INITIAL FIRE SAFETY INSPECTION REPORT

Natural Denim Ltd (Extension)

RSC ID: 25996

Date: 19-Jan-2025

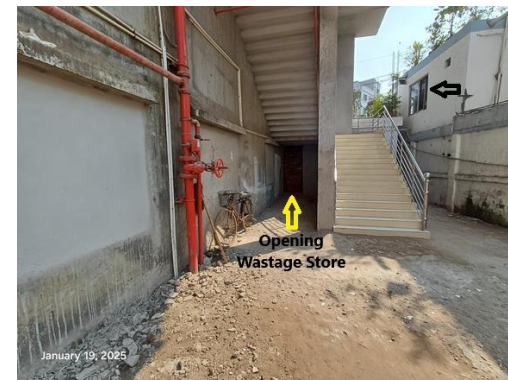
SI No.	Category	Findings	Required Action	Remediation Time Frame
F-1	Means of Egress	The exit stairs are not separated from work areas and other spaces on each floor by fire rated construction at Four (4) Storied Steel Washing Building # 04 and 2 Storied Security Building # 08. Following observations has been found a. Stair partition wall is not constructed upto ceiling. b. Manuals and certificates of installed fire rated doors are not available during inspection. c. Slab constructed above fire rated doors do not provide required fire rating. d. There is gap through out all side of fire doors. Specially gaps in bottom of fire doors exceed 19mm. e. Listing mark is not found in few vision panel.	The exit stair enclosure shall be provided with a minimum 1-hr fire resistance rating for buildings with 3 or fewer stories and a minimum of 2- hr. fire resistance rating for buildings 4 or more stories. Provide 1-hr. fire rated door and seal all penetrations and openings by 1 hr. fire rated fire rated barrier construction for building with 3 or fewer stories. Provide 1.5 hr. fire rated door and seal all penetrations and openings by 2 hr. fire rated fire rated barrier construction for building with 4 or more stories. Ensure that the fire doors are self-closing and positive latching and that they are provided with fire exit (panic) hardware where serving production floors. If fire doors are required to be held open for functional reasons, provide automatic closing devices tied to the fire alarm system.	Within 3 months

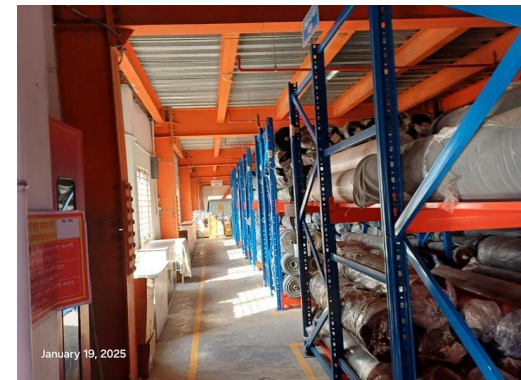
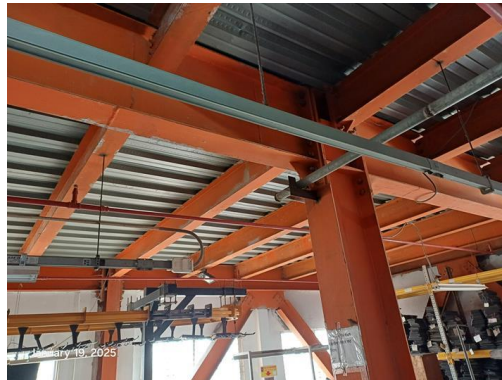
SI No.	Category	Findings	Required Action	Remediation Time Frame
F-2	Means of Egress	The external RCC stair located at South-west of washing building-4 is not having a fire separation from the building beyond 10 feet of its span as required as per clause 6.3.1.3.	Exterior exit stairs shall be separated by minimum 1-hr fire-rated construction and The rating of the exterior wall shall extend 3.05 m (10 ft.) beyond the ends of the stair structure.	Within 3 months

SI No.	Category	Findings	Required Action	Remediation Time Frame
F-3	Fire Rated Construction	The main structural elements of the four storied washing building-4 are constructed by steel which is non-rated and are found in exposed condition without any fire protection.	Assess structural fire protection requirements of steel buildings (unprotected non-combustible construction type) according to BNBC 2020. The construction type shall confirm to be in accordance with BNBC 2020 Part-3, Table 3.1.7. Ensure fire resistive rated construction following Table 3.3.1 (a) Part 3 Section-3, Table 3.2.2 and Table 3.2.3 Part 3 Section 2 and Table 4.1.1 from BNBC 2020 Part 4 Section 1. Provide design philosophy to determine the construction type as per BNBC 2020. If any construction rating requires, Consult a qualified fire protection engineer to achieve the require fire rating. Factory shall ensure that, all the design, datasheet, certificate, and the design-philosophy has been reviewed from the RSC prior to install the passive fire protection system.	Design within 2 months, installation/ modification within 4 months

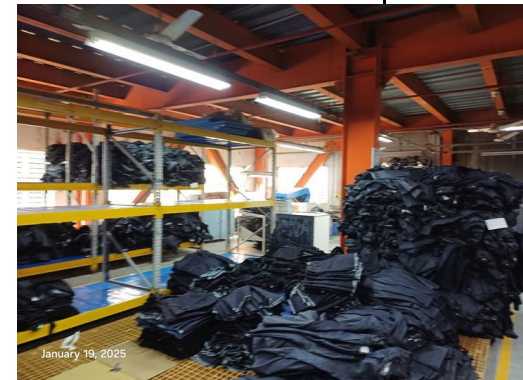
SI No.	Category	Findings	Required Action	Remediation Time Frame
F-6	Fire Rated Construction	Areas used for combustible storage (exceed 10 percent of floor area) open to the production area (washing dry process) is not separated by fire rated construction on 2nd floor of Washing building # 04.	Separate the dedicated storage rooms by minimum 1-hr fire-rated construction. Provide 0.75 hr. fire rated door and seal all penetrations and openings by 1 hr. fire rated fire rated barrier construction. Where separate storage rooms are not feasible, provide defined storage areas and limit the storage arrangement as follows: - Maximum height of 2.45m (8ft.) , maximum area of 23m2 (250 ft2) and 3m (10ft.) clear distance from adjacent another unenclosed combustible storage. - If the building/floor is sprinkler protected: maximum height of 3.66m (12ft.) and maximum area of 93m2 (1000 ft2) and 7.62m (25ft.) clear distance from adjacent another unenclosed combustible storage. -In process storage shall be limited to 10 percent of the building area of the story in which they occur.	Within 3 months

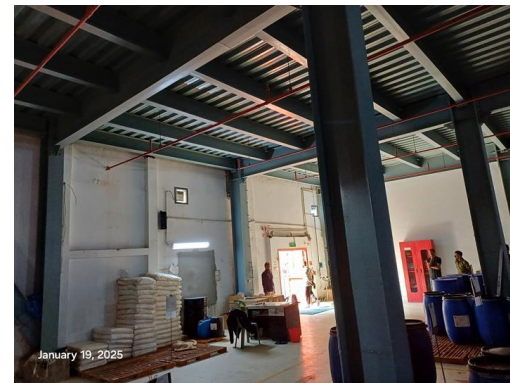
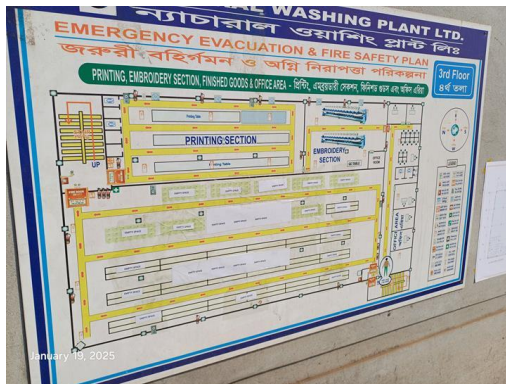
SI No.	Category	Findings	Required Action	Remediation Time Frame
F-7	Fire Rated Construction	Unsealed penetrations and openings are located in the fire-rated floor/ceiling assemblies in toilet zones from 1st floor to 3rd floor in washing building # 04.	Provide a minimum 2-hr fire-rated shaft to separate the utility risers from each floor level. Or, Seal all penetrations and openings in floors/ceiling assemblies by 3-hr fire-rated listed/certified materials. The installation of such fire-rated materials shall be following certified design and manufacturer's guidelines.	Within 3 months

SI No.	Category	Findings	Required Action	Remediation Time Frame
F-8	Fire-Rated Construction	In south side, non-rated openings are found in exterior wall of washing building-04 is adjacent to wastage shed. In north, east and west sides, non-rated opening are found in exterior wall of washing building-04 which within 4.5 m distance from other structures and boundary wall.	Seal the opening with fire rated construction in accordance to Tables 3.3.1 (a), 3.3.1 (b) and 3.2.3. (BNBC 2020, Section 2.4) or provide all openings in wall assemblies by fire-rated listed/certified louvers. The installation of such fire-rated materials shall be following certified design and manufacturer's guidelines.	Within 6 months

SI No.	Category	Findings	Required Action	Remediation Time Frame
F-9	Means of Egress	Evacuation maps are not posted at ground floor and is not matched at 3rd floor unoccupied space in Washing building-04.	Update the fire evacuation map and shall be posted at the entrance to each exit stair.	Within 1 month

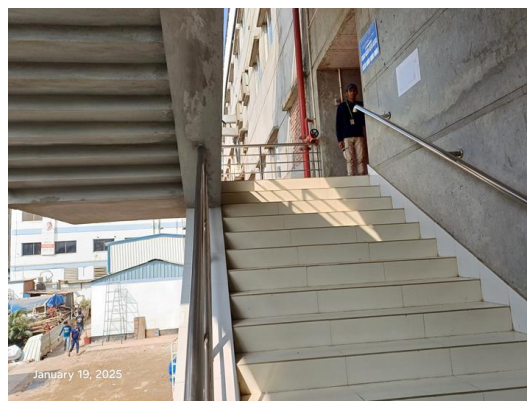
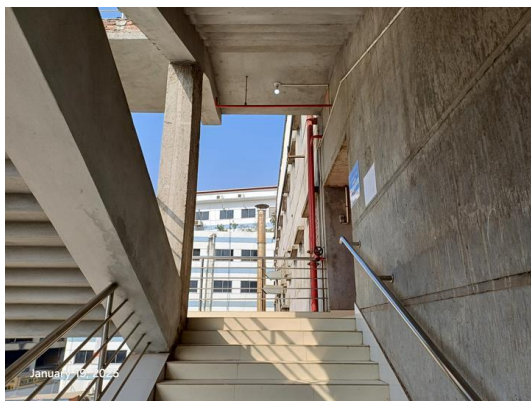
SI No.	Category	Findings	Required Action	Remediation Time Frame
F-10	Means of Egress	Both side handrails are provided at all floor in both the stairs. But, in the columns portion handrail is discontinued in south-west exterior RCC stair-2. Both side handrails are not provided in the security building.	Provide handrails on both sides of the exit stair. Intermediate handrails shall be provided when the stair width exceeds 2.2 m (87 in).	Within 1 month

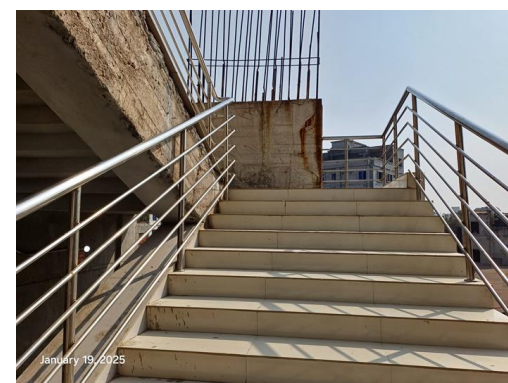
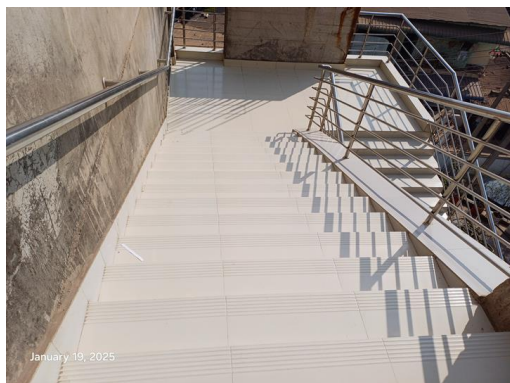
SI No.	Category	Findings	Required Action	Remediation Time Frame
F-11	Means of Egress	Height of handrail or guard in south-west exterior staircase is found 36 inch which is less than required.	Stairways serving more than three storey building having capacity more than 10 occupants shall have visual enclosures to avoid any impediments to stair use by persons having fear of height, any arrangement intended to meet this requirement shall be at least 1070 mm in height.	Within 3 months

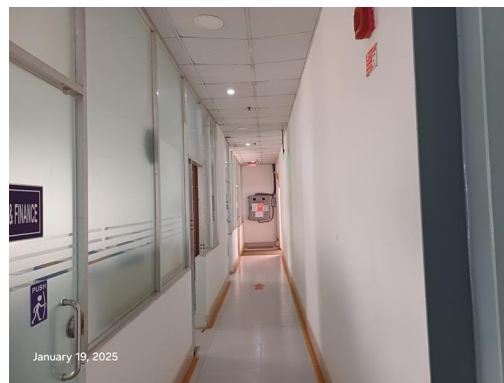
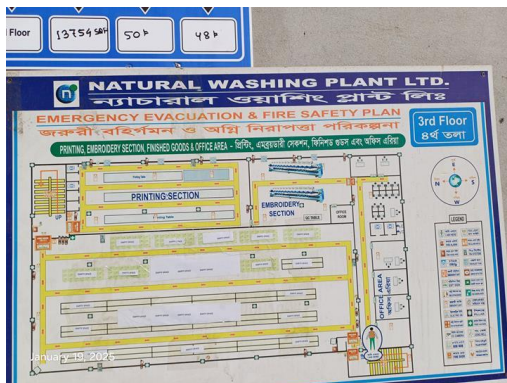
SI No.	Category	Findings	Required Action	Remediation Time Frame
F-12	Fire-Rated Construction	The fire pump room is not provided with adequate fire separation.	Provide fire pump room with 2 hr rated fire separation when not sprinklered and 1 hr rated fire separation when provided with automatic sprinklers, in accordance with NFPA 20. In the case exterior it shall be 50 ft away from another occupancy.	Within 3 months

SI No.	Category	Findings	Required Action	Remediation Time Frame
F-13	Means of Egress	Office area located on 3rd floor and Chemical store located on ground floor are provided with single exit and travel distance found 85 ft (approx.). Location: Washing Building-04	Provide two number of exits in such a way that travel distance meet the requirement in accordance to section 6.13 of the RSC Technical Guideline (Standard) V1. Or, re-arrange the area or exit in such a way that occupant load and travel distance is within limit for single exit as per the RSC Technical Guideline (Standard) V1, section 6.6.2 and table 6.6.2.	Within 3 months

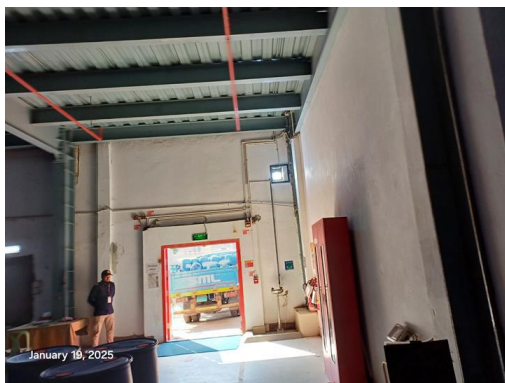
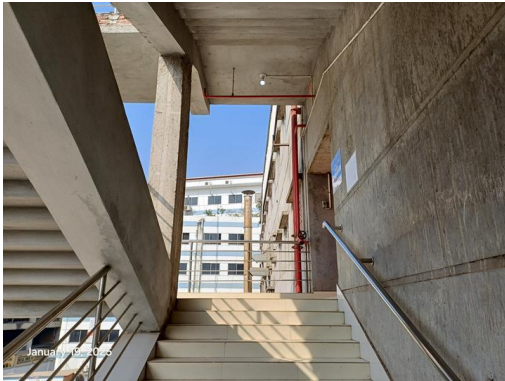
SI No.	Category	Findings	Required Action	Remediation Time Frame
F-14	Means of Egress	Abrupt changes in the elevation of walking surfaces were observed, not meeting the RSC Technical Guidelines (Standard) ¹ V1.0 Section 6.3.4.	Abrupt changes in elevation of walking surfaces shall not exceed ¼ in. unless provided with a beveled slope of 1 in 2 that do not exceed ½ in. Changes greater than ½ in. shall meet the requirements for RSC Technical Guidelines (Standard) ¹ V1.0 Section 6.3.5.	Within 3 months

SI No.	Category	Findings	Required Action	Remediation Time Frame
F-15	Means of Egress	Occupant load signs are not posted on 1st floor and ground floor of washing building-4 and all floors in security building-8.	Post the occupant load for every assembly and production floor in a facility in a conspicuous space near the main exit or exit access doorway for the space.	Within 1 month

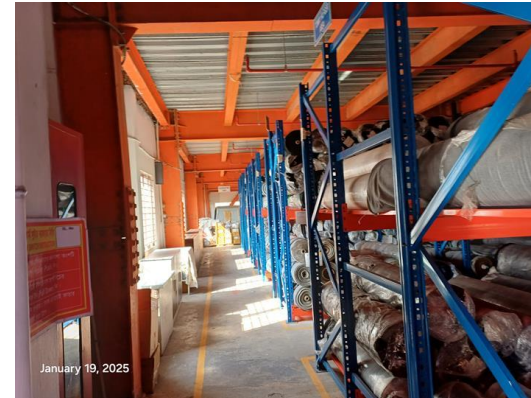
SI No.	Category	Findings	Required Action	Remediation Time Frame
F-21	Fire Protection System	Insufficient number of portable fire extinguishers are found on 1st and 3rd floor of washing building-04. Thermo boiler shed-5 and compressor shed-6 is also not provided with portable fire extinguishers.	Portable fire extinguishers shall be installed throughout all new, interim, and existing facilities in accordance with BNBC 2020 and NFPA 10. Extinguishers shall be placed so that maximum travel distance to the nearest unit shall not exceed 30 m (100 ft).	Within 2 months

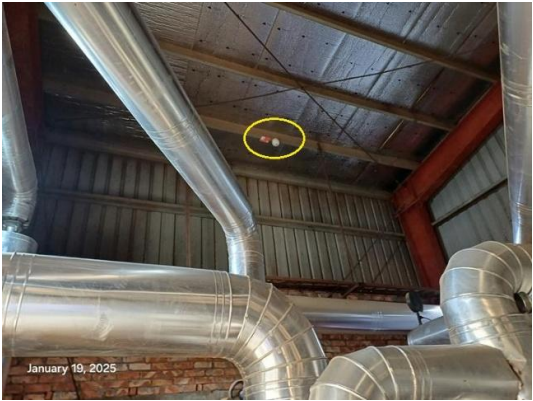
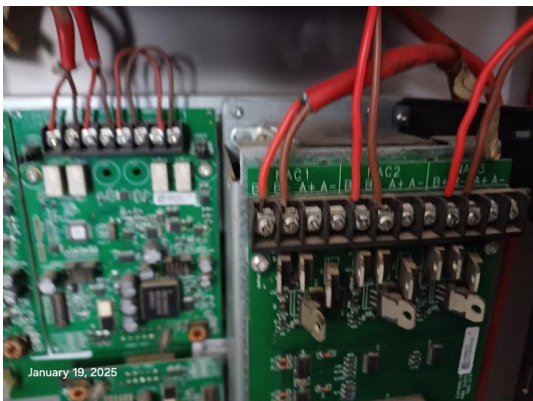
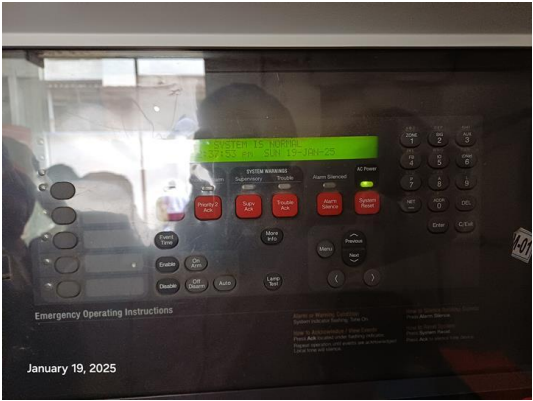
SI No.	Category	Findings	Required Action	Remediation Time Frame
F-23	Fire Alarm & Detection System (FADS)	All the buildings and sheds have been provided with addressable fire alarm and detection system. Installation work is on-going. In washing building-4, detectors are not installed in floor and have direct dependancy on installed sprinkler system. Factory used a common FACP with another factory (RSC ID # 9602). The factory needs to submit the design to RSC for initial review covering both the ID (9602 & 25996) sharing the common system. After installing centralized fire alarm and detection system, functional test need to be performed and records of regular testing or maintenance should be kept.	Design & Installation of Fire Alarm system shall be in accordance with RSC standard and NFPA 72. Submit design, documents and calculations to RSC for review prior installation/modification. Once the design is reviewed, install/modify the fire detection and alarm system throughout the building in accordance with review comment, RSC/ RSC Technical Guidelines (Standard) and NFPA 72. Complete the fire alarm installation as per NFPA 72. After installation the owner shall conduct internal testing and commissioning and then contact the RSC for witness of final acceptance testing. Submit as-built drawings, testing records, equipment certification and other relevant documentation to the RSC for review and approval. Modification (if required) shall have to done as per the reviewed design and NFPA- 72. Upon approval & modification (if required) the factory shall inform RSC to conduct final testing and commissioning verification of the system for final acceptance.	Design within 2 months, installation/modification on within 4 months

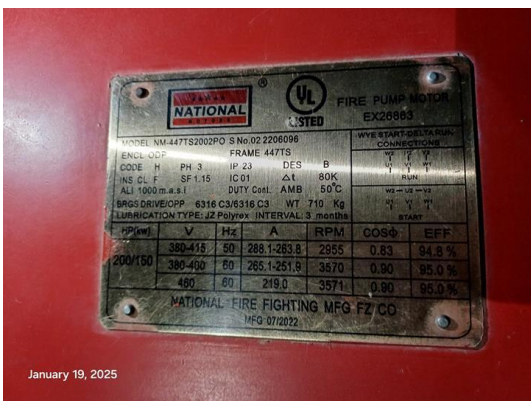
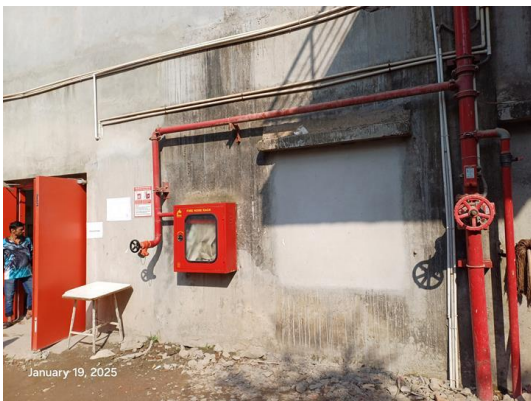
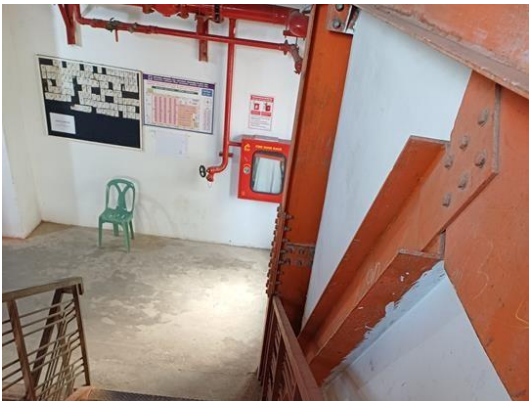
SI No.	Category	Findings	Required Action	Remediation Time Frame
F-24	Inspection, testing, and maintenance (Fire Alarm System)	Inspection, testing and maintenance of the addressable fire alarm and detection system is not in accordance with NFPA 72, and the RSC Technical Guidelines (Standard).	Inspect, test and maintain the addressable fire alarm and detection system and keep written records on- site, in accordance with NFPA 72 and the RSC Technical Guidelines (Standard)	1 month after installation
F-25	Fire Protection System (Standpipe)	The building has highest occupiable floor level more than 11 meter (33 ft.) which requires standpipe system.	Design & Installation of standpipe system, fire pump and water supply system shall be in accordance with RSC standard, NFPA 14, NFPA 22, NFPA 25 and NFPA 20. Submit design, documents and calculations to RSC for review prior installation/modification. Once the design is reviewed, Install a standpipe system in accordance with RSC standard 5.4 and NFPA 14. A class III system shall be installed in buildings with the highest occupiable floor 10 m (33 ft.) above grade or more. A class I system shall be permitted in buildings protected throughout by an approved automatic sprinkler system. Also, install fire pump in accordance to RSC standard and NFPA 20. Submit the as-built standpipe system, fire pump and water supply system drawing to RSC for review. Once reviewed, install or modify the standpipe system throughout the building in accordance with RSC standard and NFPA 14, 20,22 and 24. After installation the owner shall contact the RSC for witness of conducting the final acceptance testing of the standpipe system, fire pump and water supply system.	Design Review within 2 month and installation within 4 months

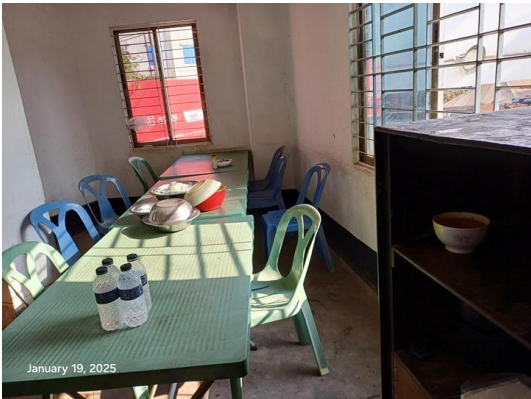
SI No.	Category	Findings	Required Action	Remediation Time Frame
F-27	ITM of Standpipe System	Inspection, testing and maintenance for the standpipe system was not in accordance with standard.	Inspect, test and maintain the standpipe system in accordance with NFPA 25 and keep written records on-site.	Within 1 Month after installation
F-28	ITM of Pump System	Inspection, testing, and maintenance for the Fire pump & water system is not in accordance with NFPA 25 or as per RSC standard.	Inspect, test and maintain the fire pump & water system and keep written records on-site, in accordance with NFPA 25 or as per RSC standard.	Within 1 Month after installation
F-29	ITM of Sprinkler System	Inspection, testing, and maintenance for the sprinkler system is not in accordance with NFPA 25, 13 or as per RSC standard.	Inspect, test and maintain the sprinkler system and keep written records on-site, in accordance with NFPA 25, 13 or as per RSC standard.	Within 1 Month after installation
